NONCONFORMANCE REPORT (NCR)

Wolf Creek 7158

DESCRIPTION OF NONCONFORMANCE

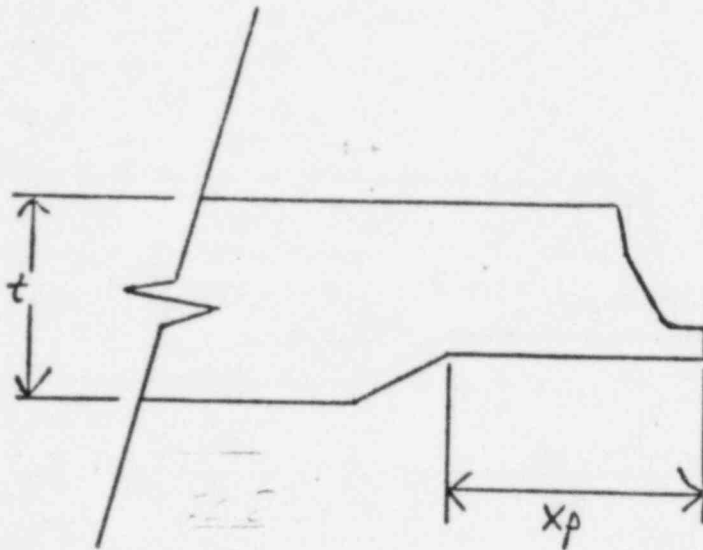
DEPTH OF COUNTERBORE IS EXCESSIVE.

REQUIREMENTS ARE THAT DEPTH SHOULD EQUAL $1" + \frac{1}{2}" - \frac{1}{16}"$.

COUNTERBORE DEPTH MEASURES 2".

$$t = 1.000"$$

$$X_p = 2"$$

PROCEDURE REQUIREMENTS ARE AS FOLLOWS:

$$X_p = t^{+\frac{1}{8}}_{-\frac{1}{16}}$$

This is the
Not shown in the
IN service inspection
scope. IAW J. Johnson
PPE LTR of 11-19-81
No Deficiency exists
Per Bill Flint
from Hensley

SUPPLEMENTAL SHEET

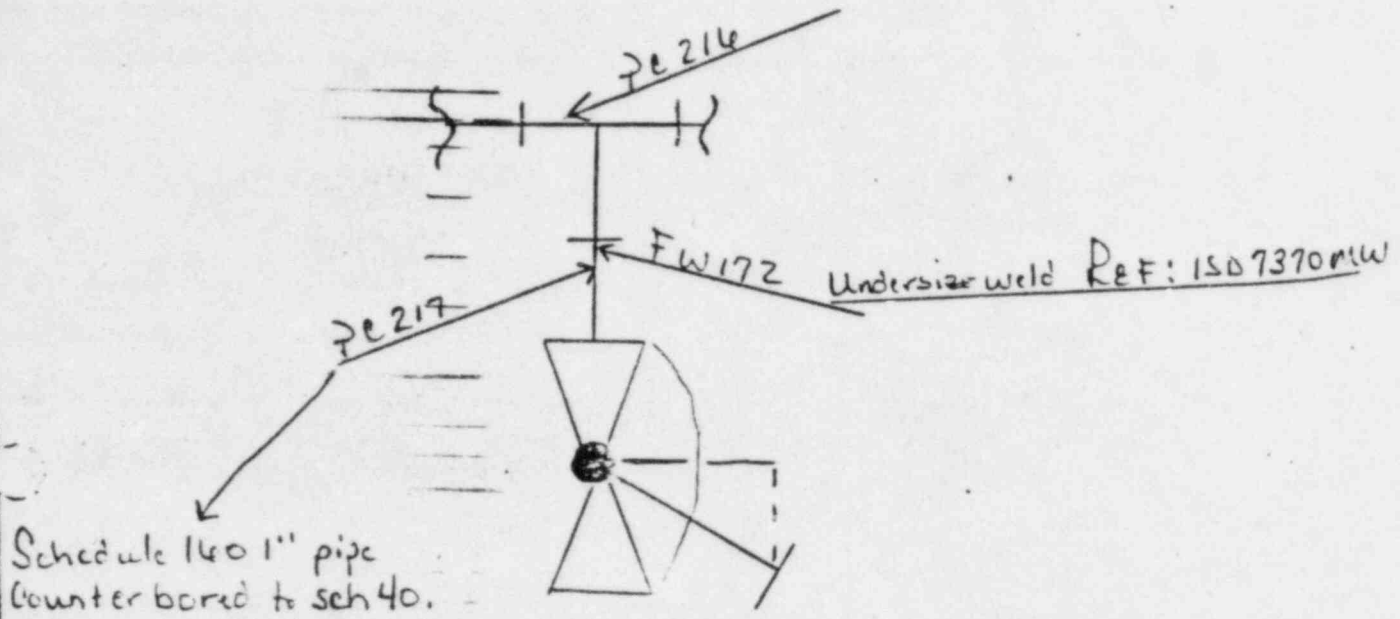
DESCRIPTION: Piece # 217, 1" sch 160 ss pipe on SP043 was counter bored to sch 40 pipe. NOTE 5 of the D-1 Sheet indicates that this should be sch 80 pipe counter bored to sch 40. SP043 has an open Deficiency Report (ISD 9370mw) against it for undersized socket welds. (SEE continuation sheet).

Piece # 217 is joined to piece # 214 by FW172 which is on
 ISD 7370 mw as being undersized. LOCATION: Small Pipe Spec
 Fab Shop lay down yard.

Based on the information above we do not have a procedural violation. We do have a conflict between the D-1 sheet and the SPM, therefore in lieu of a D/R, generate a surveillance report, stating the details of the situation.
